RS-06-105

Dresden Nuclear Power Station, Unit 3
Renewed Facility Operating License No. DPR-25
NRC Docket No. 50-249

Subject: Request for Technical Specifications Change for Minimum Critical Power Ratio
Safety Limit

ATTACHMENT 2
Markup of Proposed Technical Specifications Page

2.1.1.2 MCPR (continued)

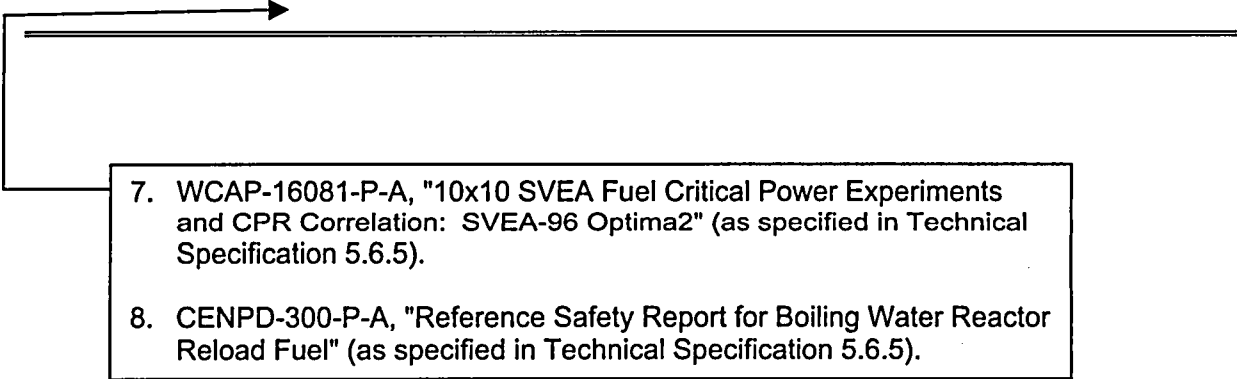
References 2, 3,
4, 5, and 8
